**ADDENDUM**  
**MEETING OF THE PLANNING COMMITTEE**  
**TUESDAY 01<sup>st</sup> NOVEMBER 2023**

**PLANNING APPLICATION: 23/00822/F Land At Partridge Mead Banstead Surrey SM7 1LW**

**PLANNING APPLICATION: 23/00821/F Land At Hatch Gardens Tadworth Surrey**

**PLANNING APPLICATION: 23/00816/F Garage Block Ferriers Way Epsom Downs Surrey**

**SITE WIDE**  
**VERTICAL PRIVACY BLADE DETAIL**  
**HATCH GARDEN**

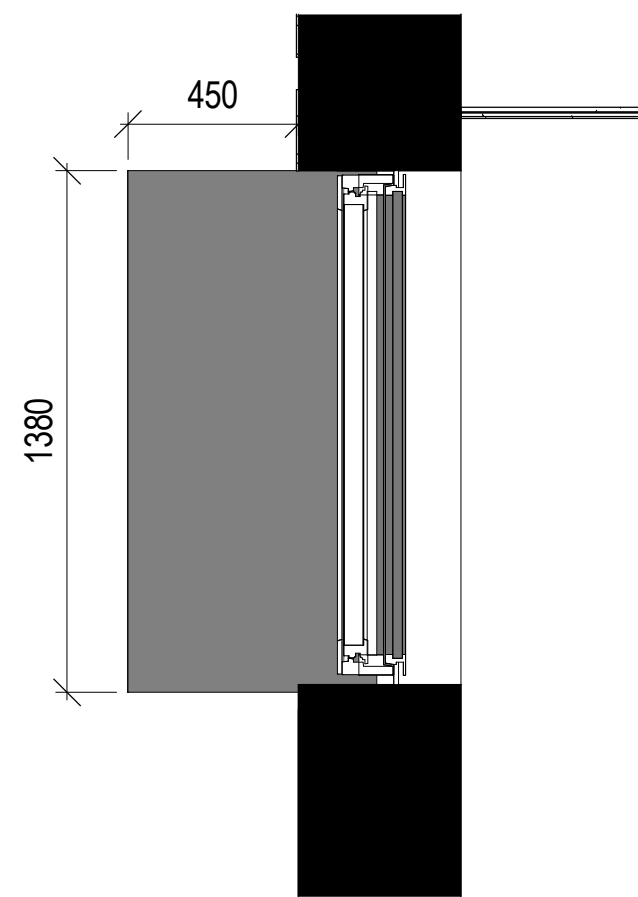
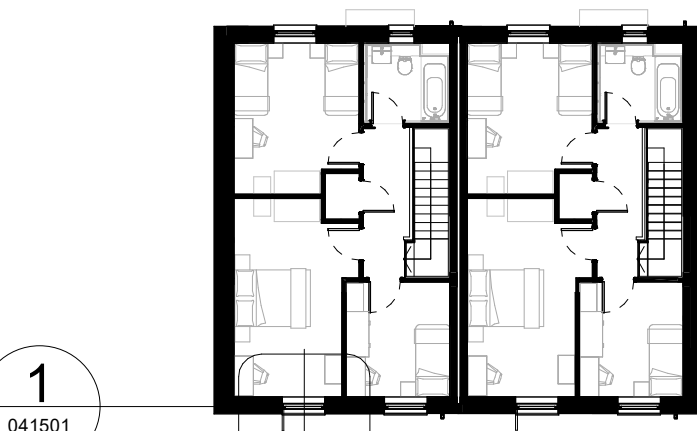
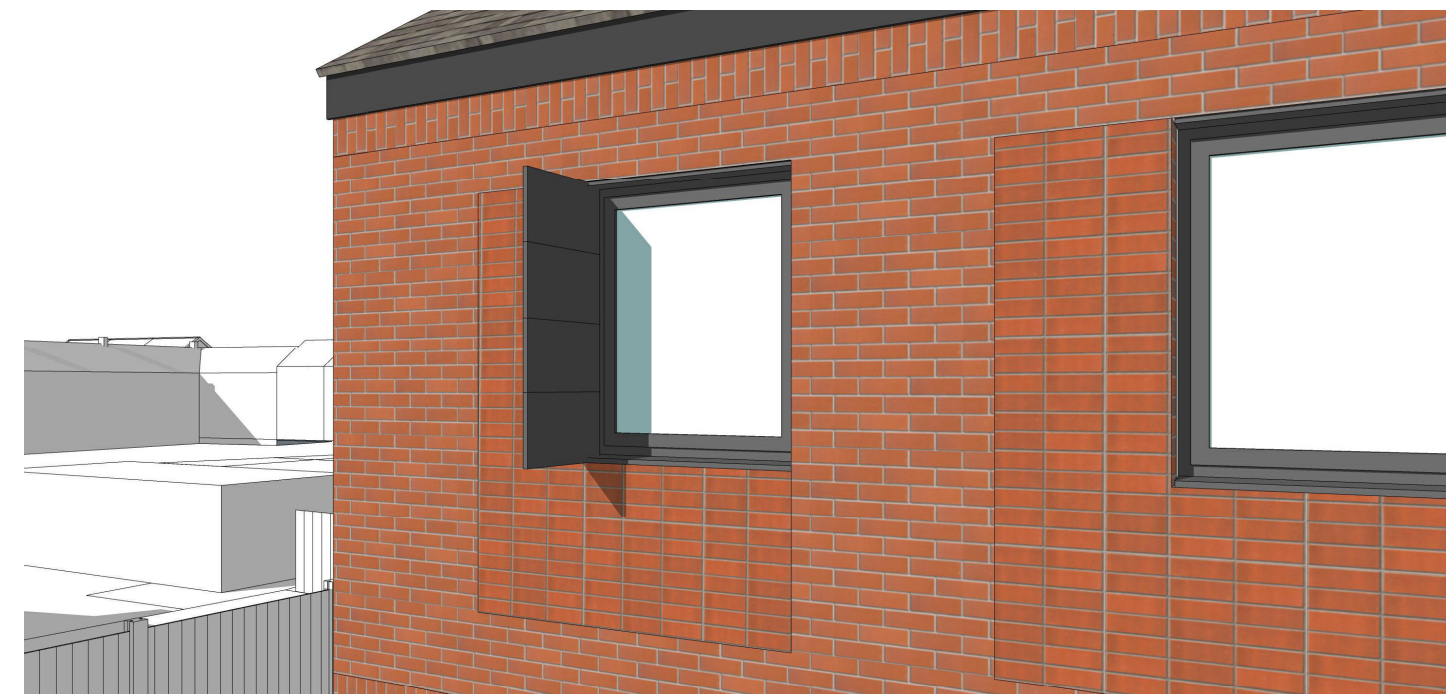
**Vertical privacy blade information**

The plans showing the privacy blade information were not included within the agenda pack. For ease of reference a copy of the plan is attached at **Appendix A** of this addendum

PROPOSED BLOCK PLAN  
 1:500 SCALE

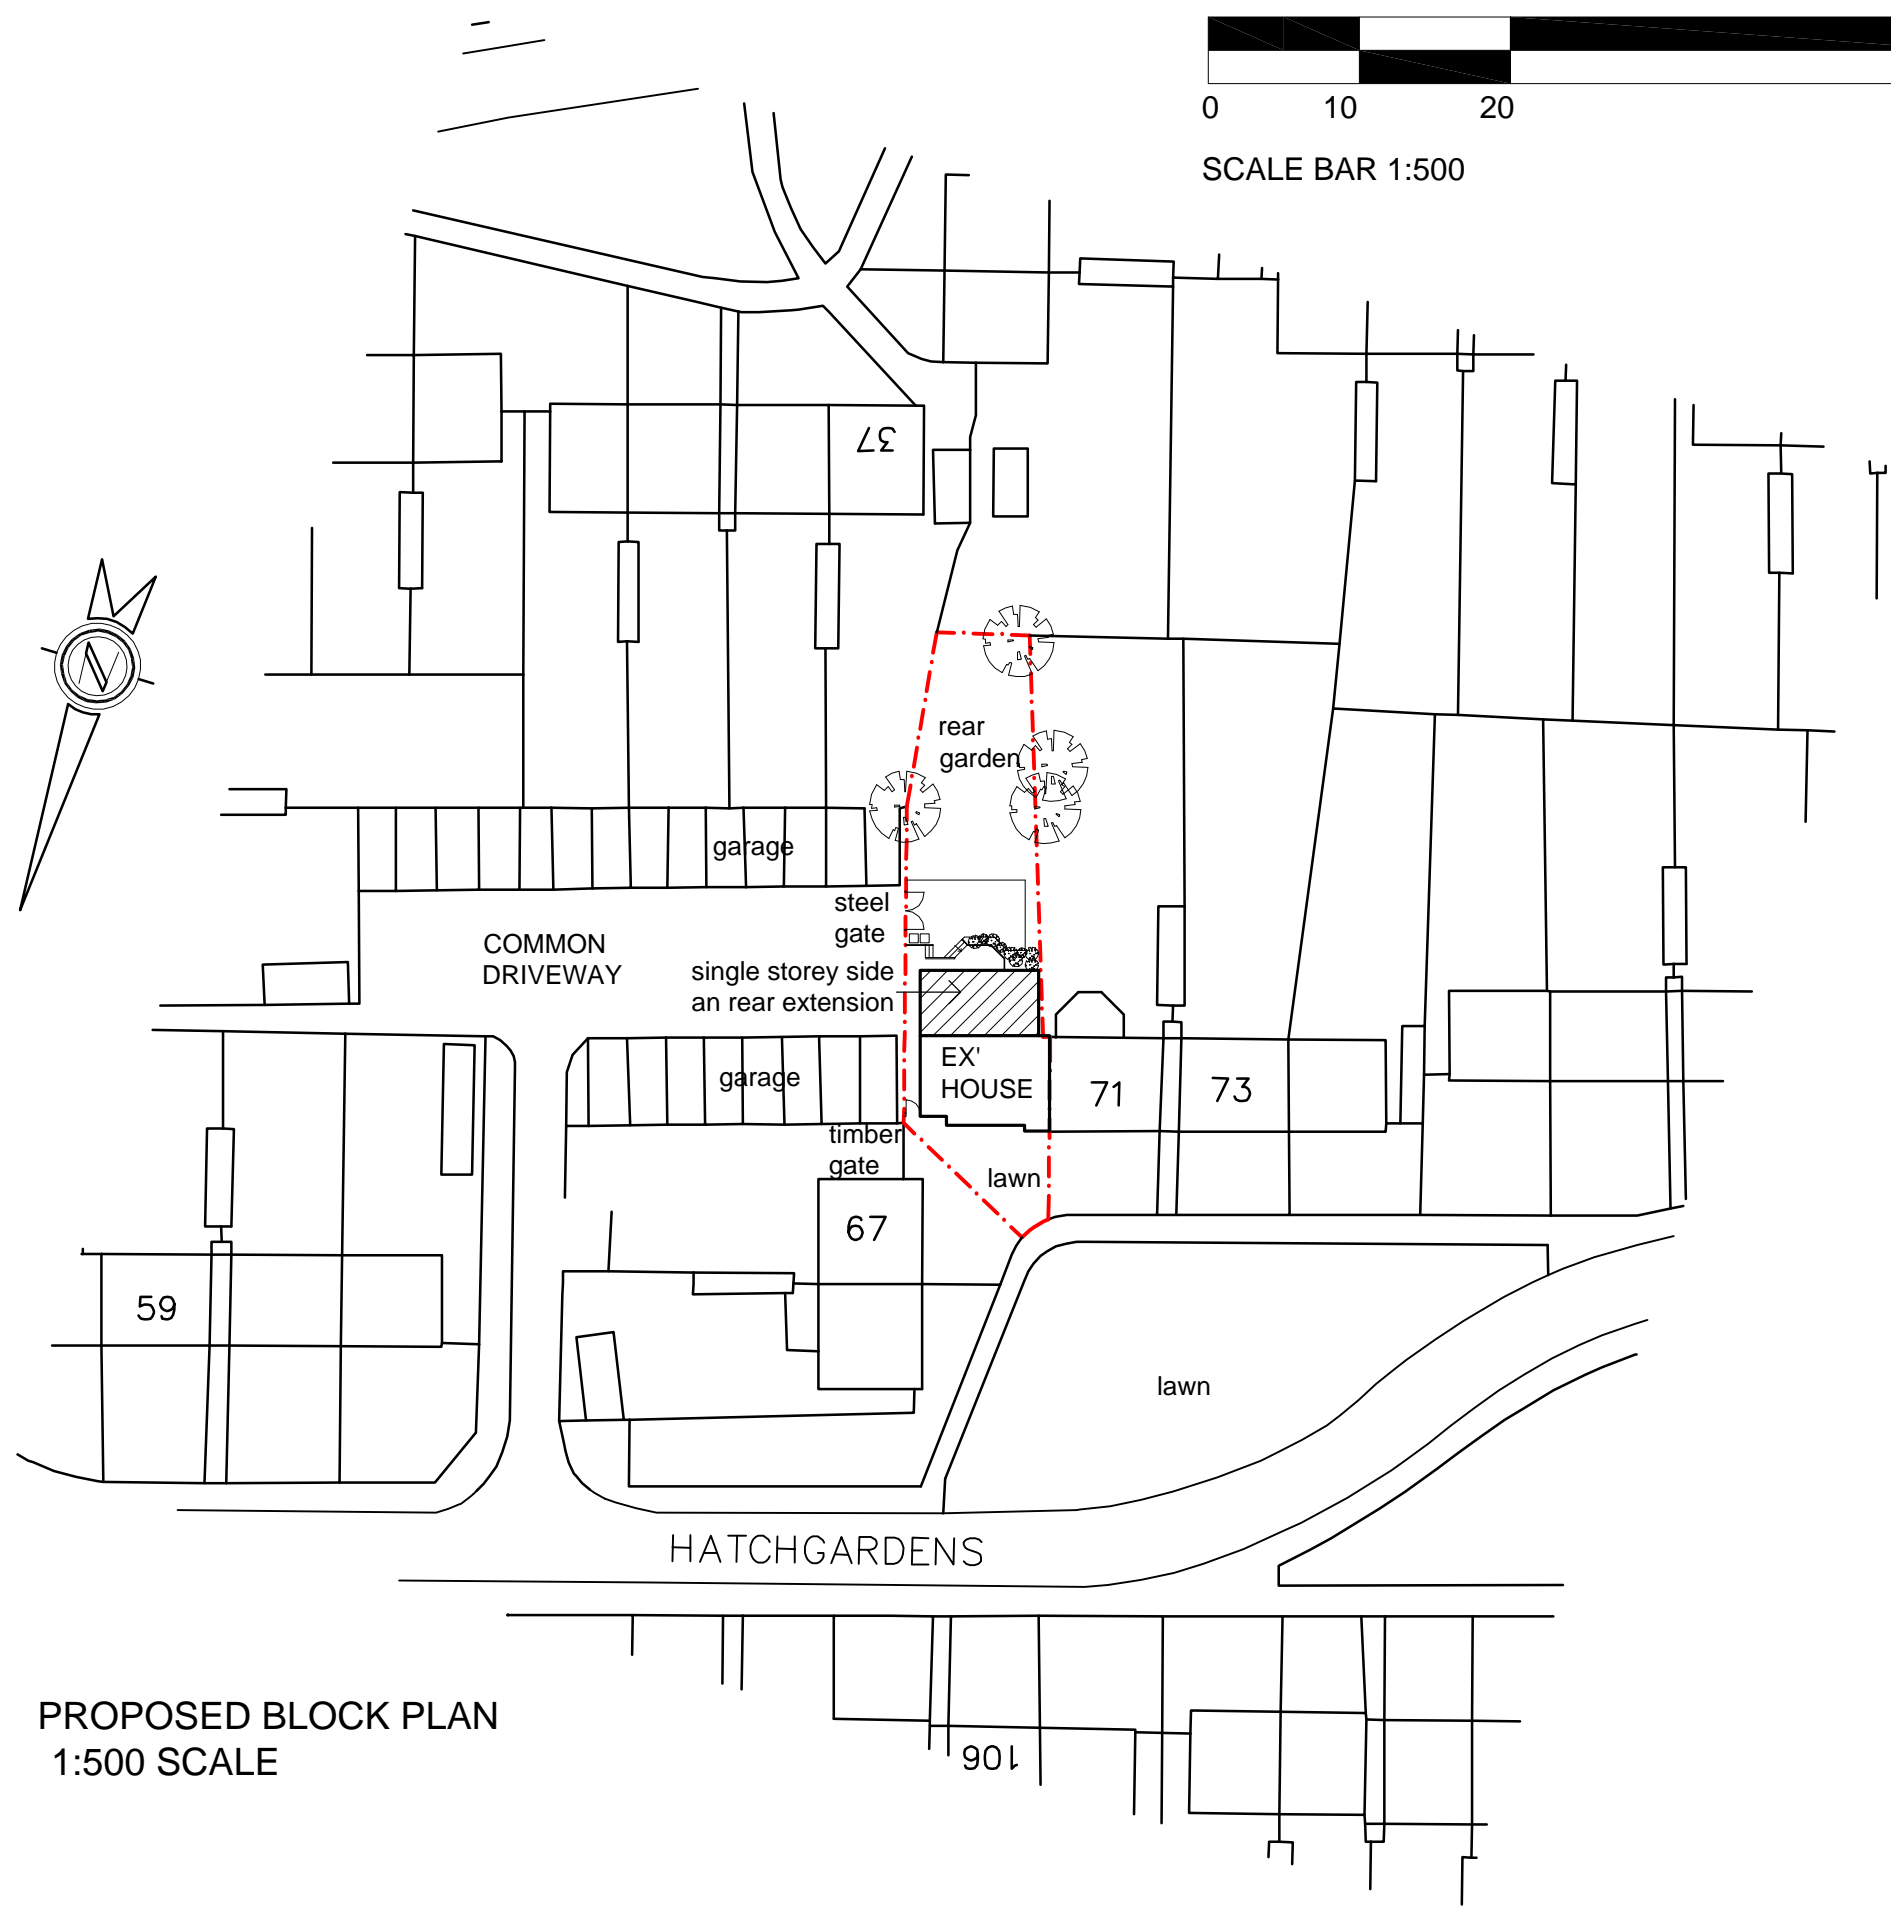
It was noted on the Planning Committee Site Visit that the boundary between the site and the property to the west, 69 Hatch Gardens, does not match that shown on the submitted location plan. A photograph showing the discrepancy is shown at **Appendix B**.

On review of the 2013 permission referred to in the committee report and the most recent 2018 permission (18/01749/HHOLD) it is evident that the red line for the current application is correct and that the applicant does not own the strip to the west of the northern garages (the red line plan for the 2018 permission and proposed plans are attached at **Appendix C**). It appears that the neighbour did not replace the boundary when they completed the extensions approved under the 2013 and 2018 permissions and therefore they appear to be using part of the Raven application site as bin storage.

*“I can confirm that the red line boundary has been drawn correctly on the plans and is accurate according to the title plans.*

*As you’ve identified, it is the neighbour who has incorrectly built the wall which has extended into Raven’s land.”*

Therefore officers are satisfied that the red line plan for the current application is correct. Any issues regarding land ownership are private matters between the applicant and the neighbour and this matter will need to be resolved prior to commencement of the development. **Appendix C** also includes plans showing what the side windows at no. 69 serve. As per paragraph 6.26 of the committee report these windows are either secondary windows or serve non-habitable rooms, two of which are high level, and therefore there would be no impact on the neighbouring property in this regard.
